# **Amendment Report**

## **Forest Glen Solar Farm**

**April 2022**

**Project Number: 22-029**

Figure 3-1 Updated indicative infrastructure layout for the Forest Glen Solar Farm. The Visual set-back area for R6 is located on the western boundary of the Proposal area. The Development footprint remains unchanged.

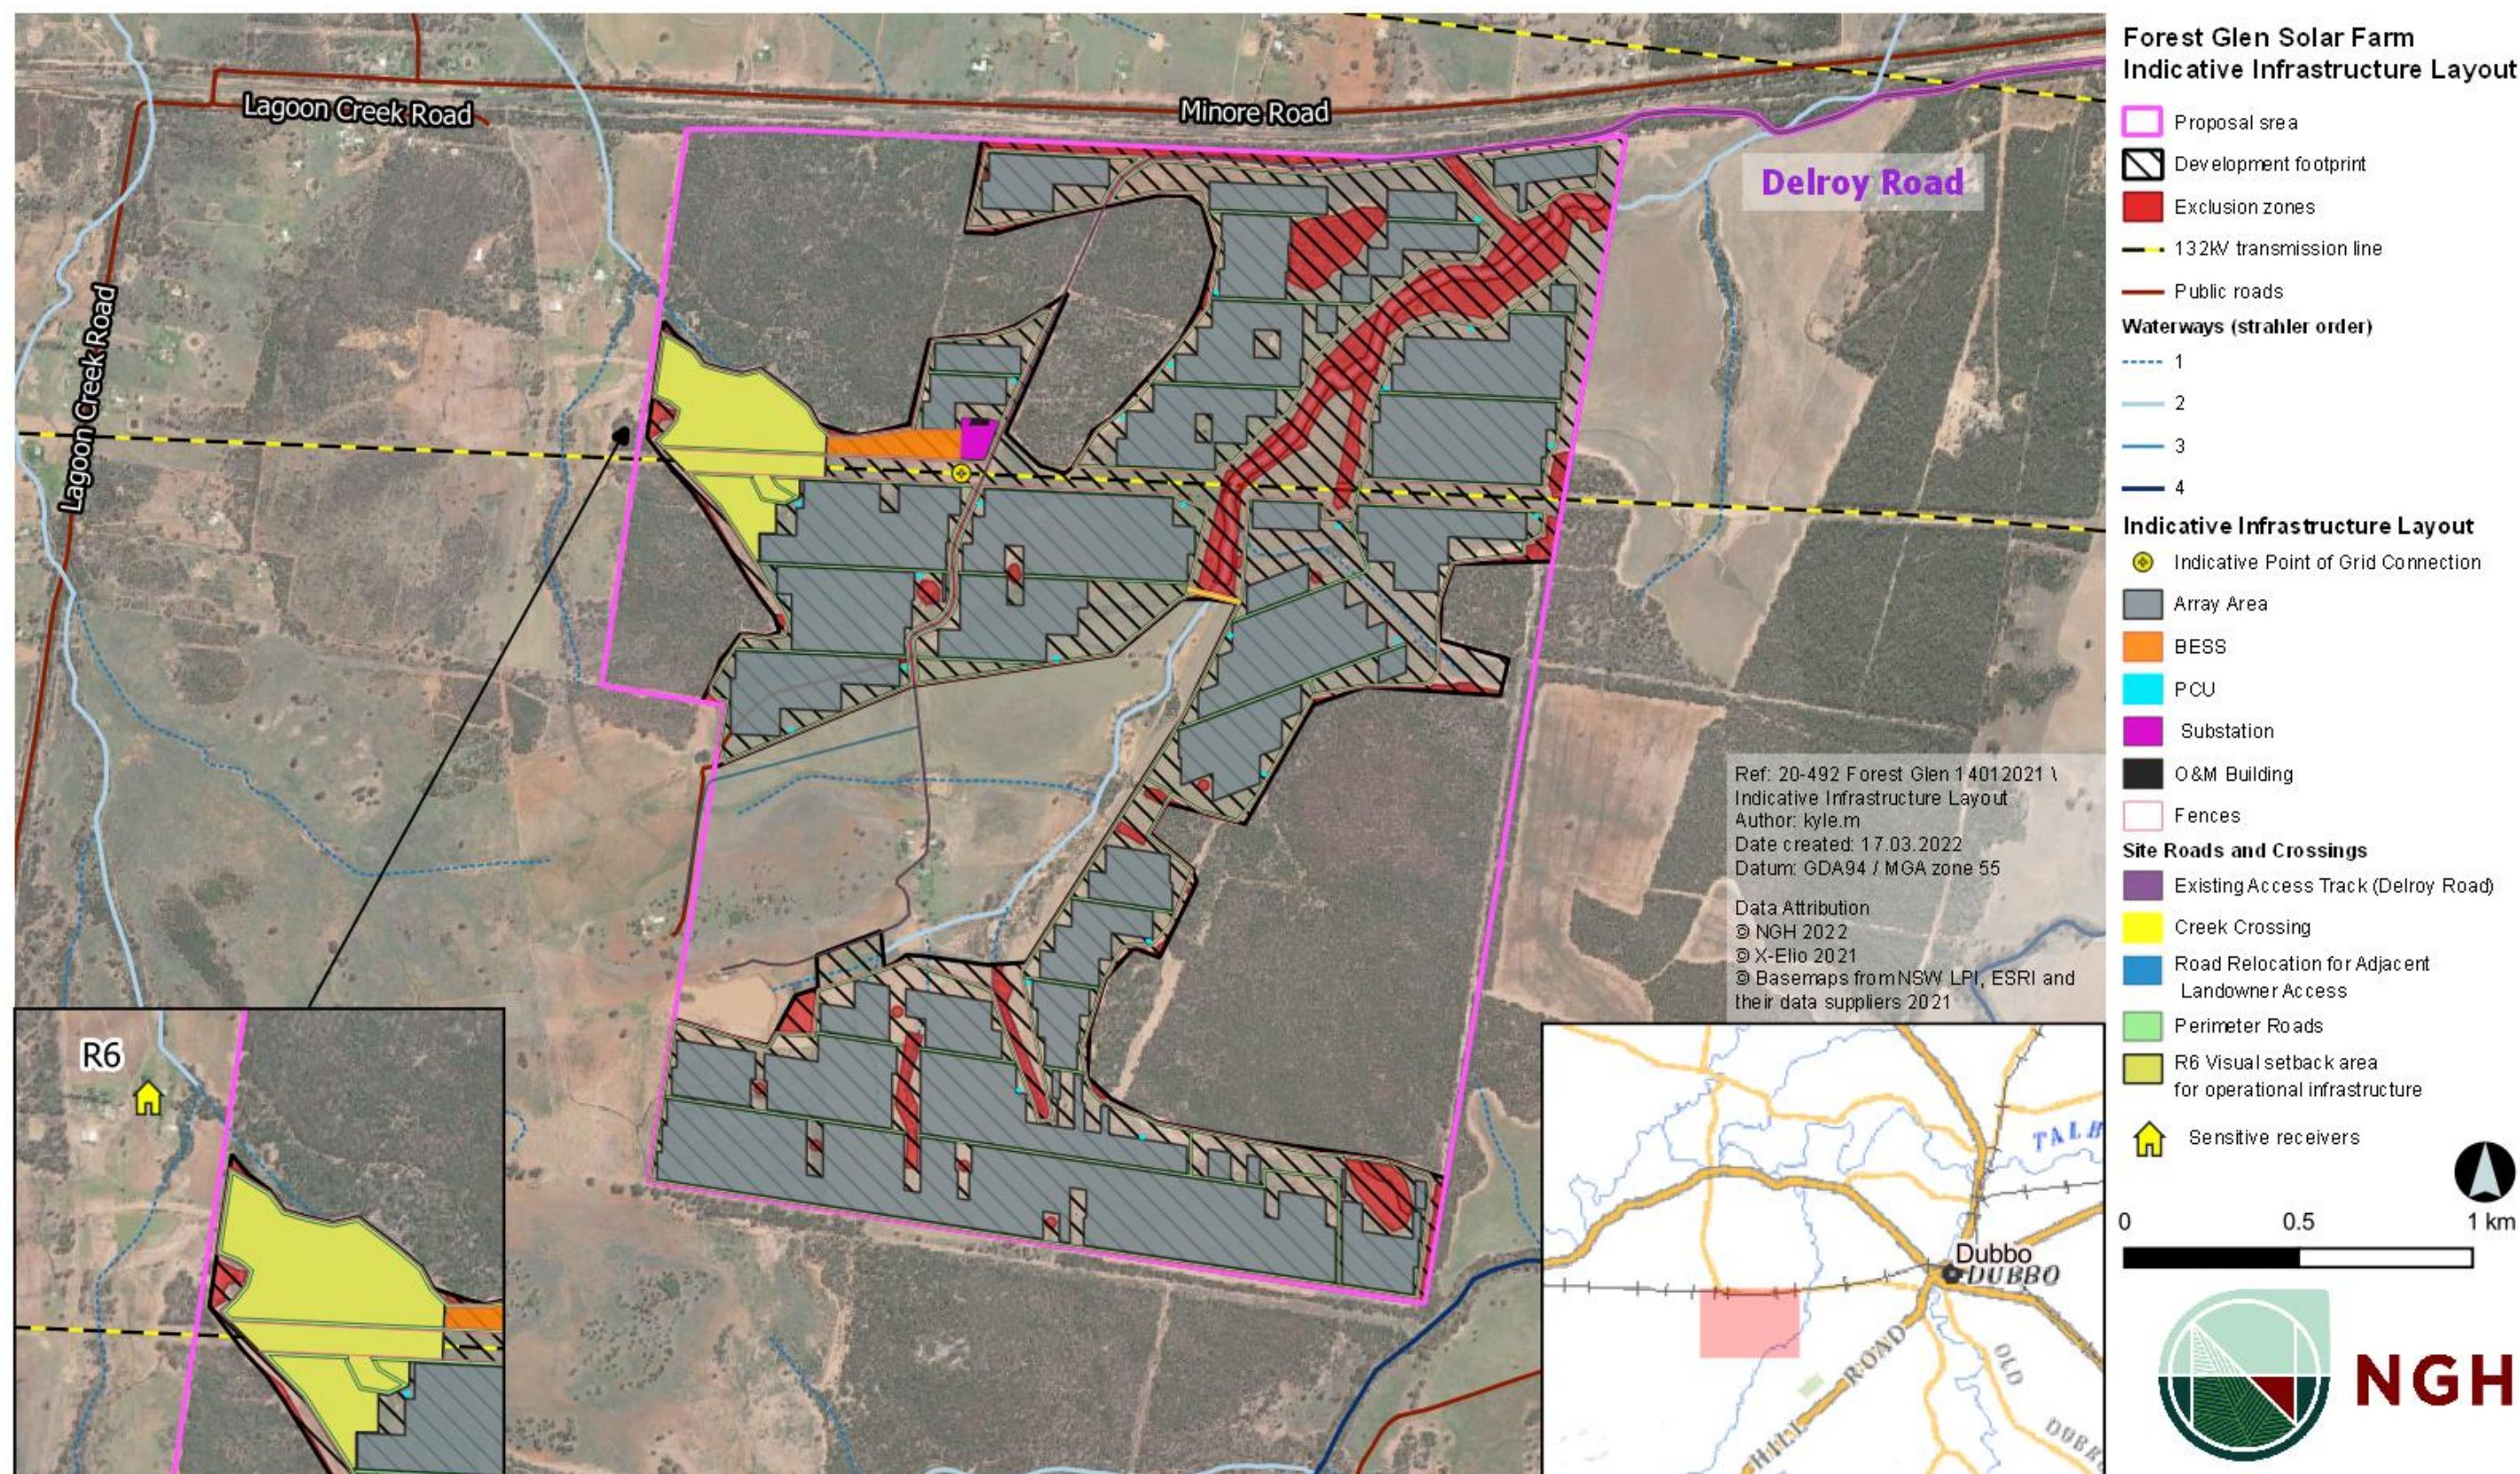
Following landowner consultation, the Proponent has committed to establishing a specific visual impact setback area on the western edge of the Proposal site to mitigate the visual impact of permanent above ground operational infrastructure to Receiver R6.

This visual setback area is now displayed as part of an updated indicative infrastructure layout for the Proposal in Figure 3-1 below and is reinforced in the updated visual impact mitigation commitments. The assessed Development footprint for which development consent is sought remains unchanged from the EIS, as construction works and the establishment of permanent tracks may still be required within this set back area.

- ***No above ground operational infrastructure would be constructed within the visual set-back area for R6 as mapped in Figure 3-1. This set back is included manage the operational visual, glare and glint impacts of the project on this receiver.***
- **No security lighting to be installed on this perimeter of the project, within 500m of the residence (R6).**

Figure 3-2 Lots 51/ DP755094 and Lot 52/DP755094. Right of carriageway now included for Lot 51.

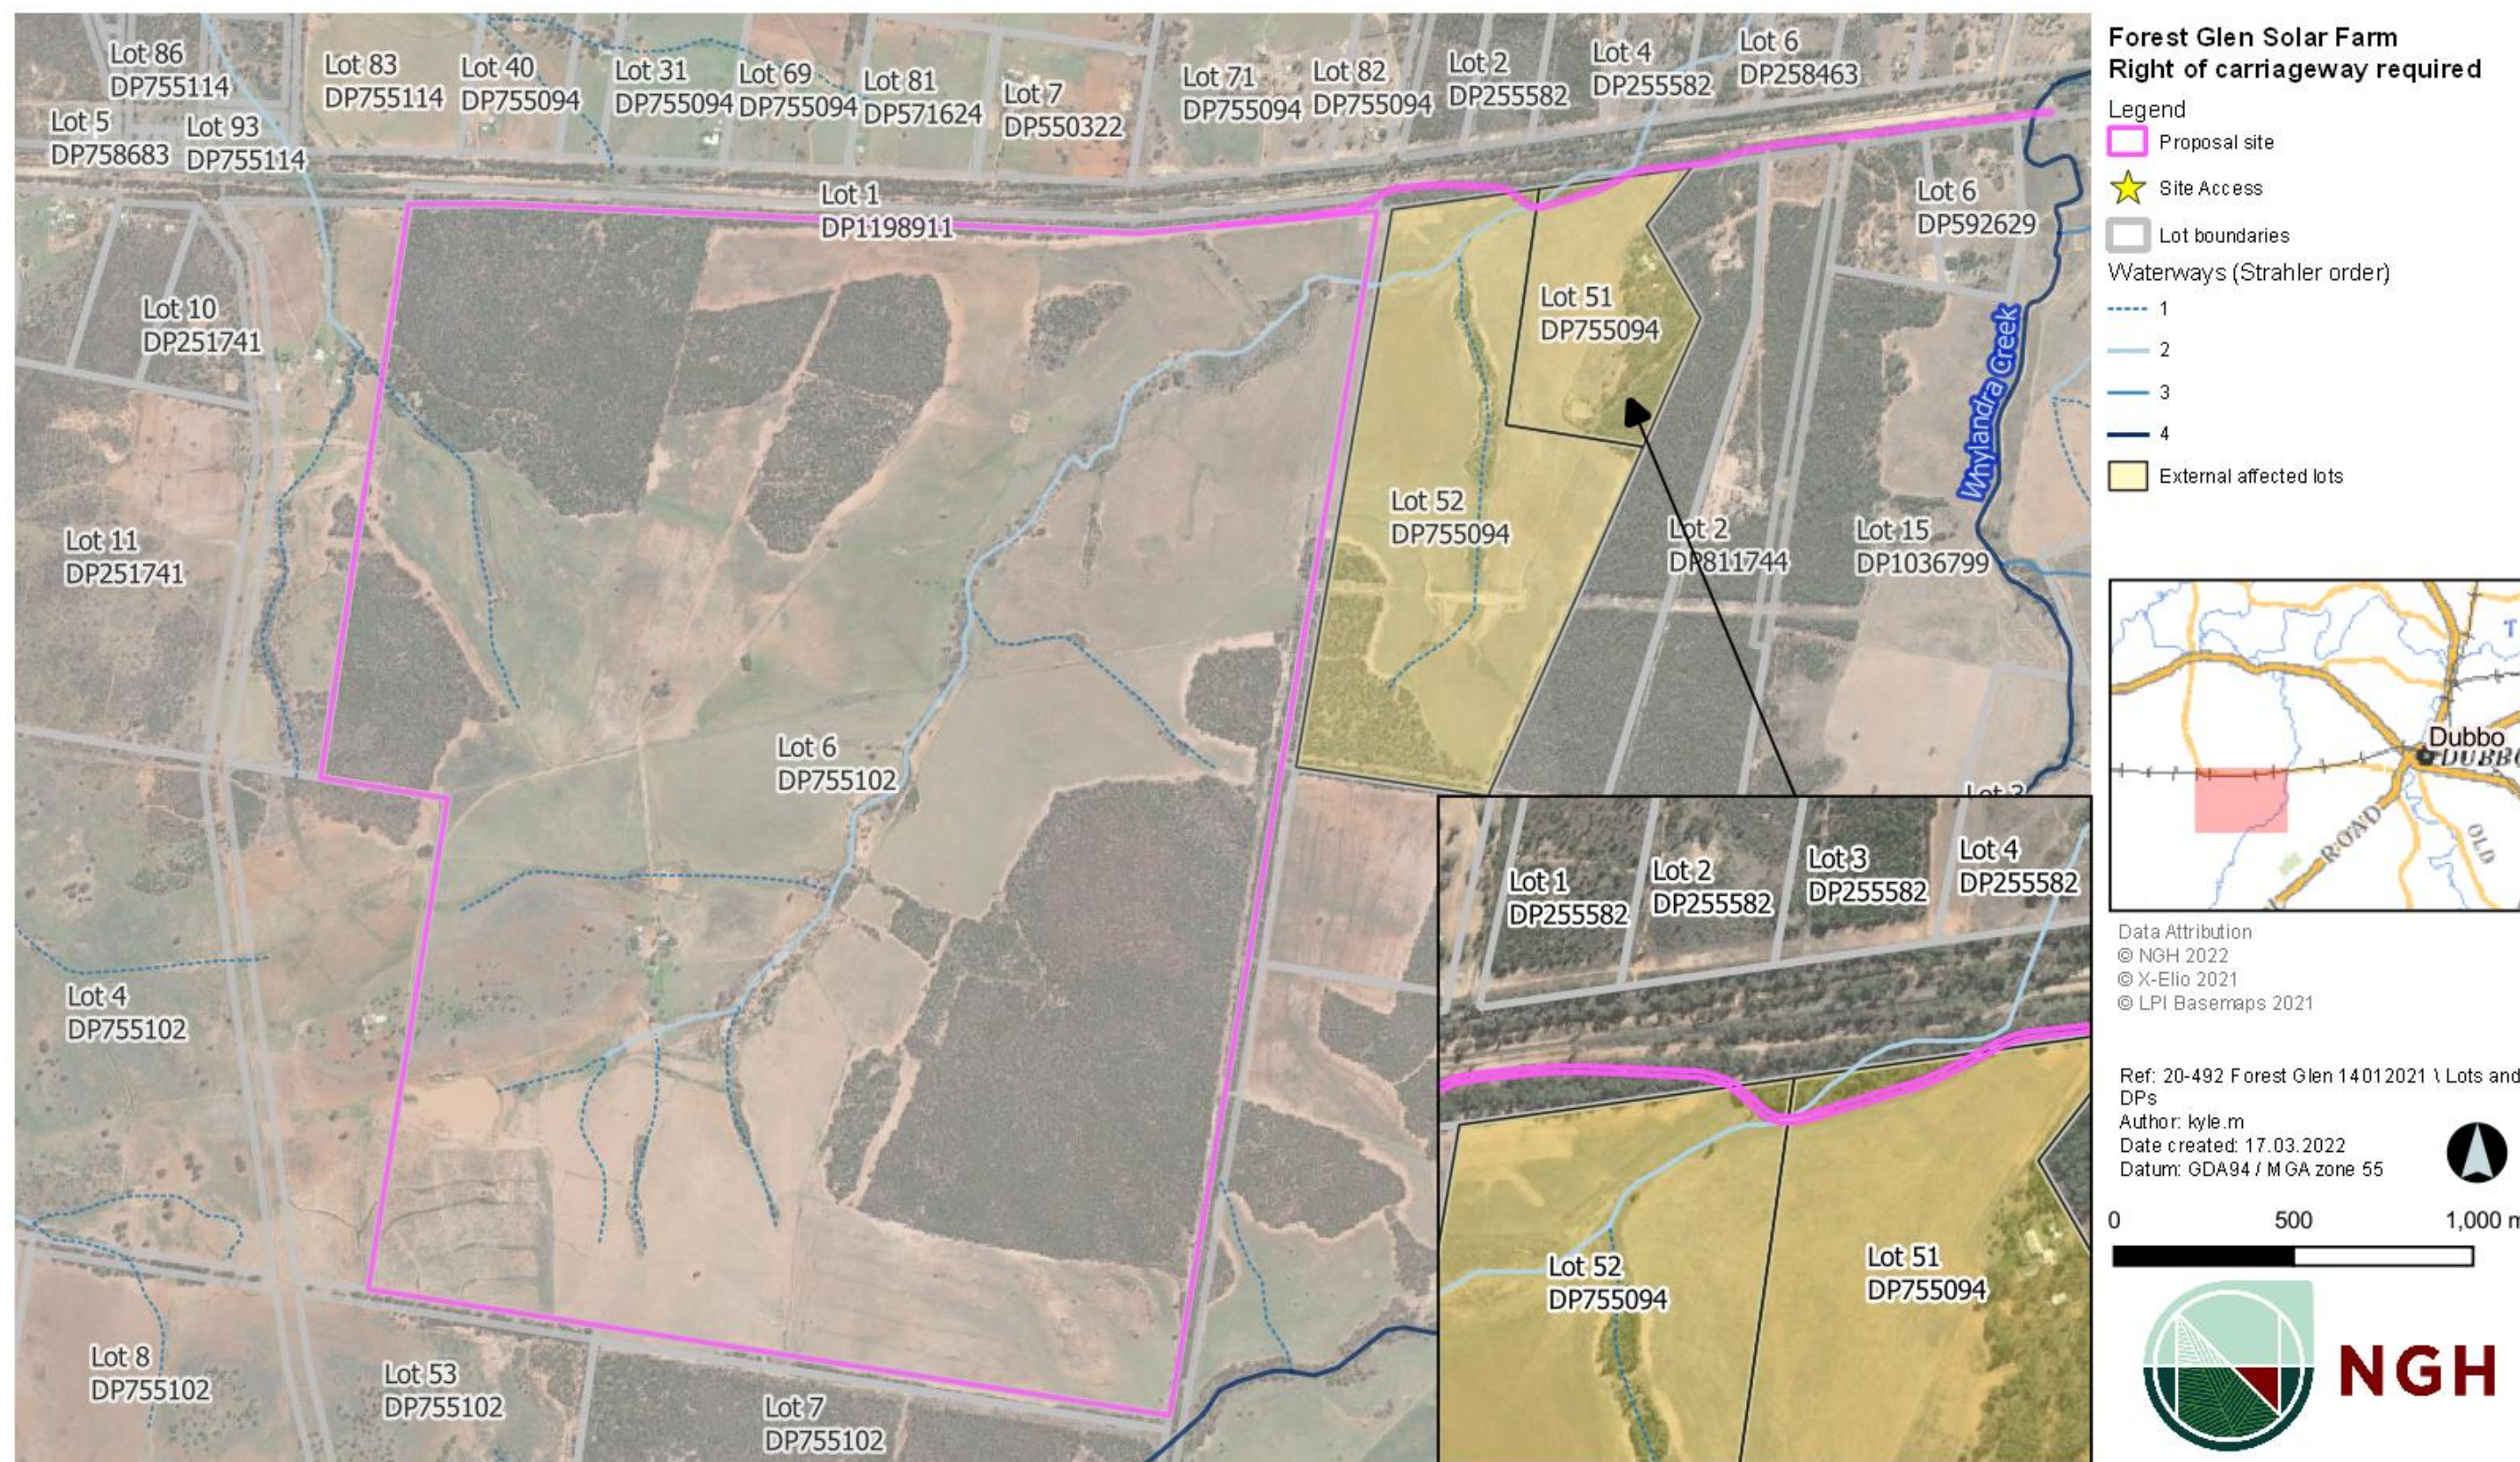
As described in the EIS, Delroy Road would be the primary construction and operational site access road to the Proposal. Delroy Road has recently been gazetted as a local Council road. However, portions of it traverse private freehold (Lots 51/ DP755094 and Lot 52/DP755094). Refer Figure 3-2.

Following Council consultation, the Proponent has sought and obtained landowner consent to establish a right of way carriageway across these lots, to ensure legal access to the Proposal site. An additional land owner consent for right of access through the affected private lots has been provided to DPE with this Amendment Report.

Delroy Road has recently been gazetted as a local Council road. However, portions of it traverse private freehold (Lots 51/ DP755094 and Lot 52/DP755094). Refer Figure 3-2. Dubbo Regional Council have stated that it will be necessary for 'Rights of Carriageway' to be created to provide the landowner with legal access to the Proposal site. Following Council consultation, the Proponent has sought and obtained landowner consent to establish a right of carriageway , to ensure legal access to the Proposal site across these sections.

There are no additional impacts generated by this action. There is no material change to the Delroy Road carriageway beyond what is described in the EIS, and landowner consents have been provided where the road traverses private freehold (Lots 51/ DP755094 and Lot 52/DP755094).
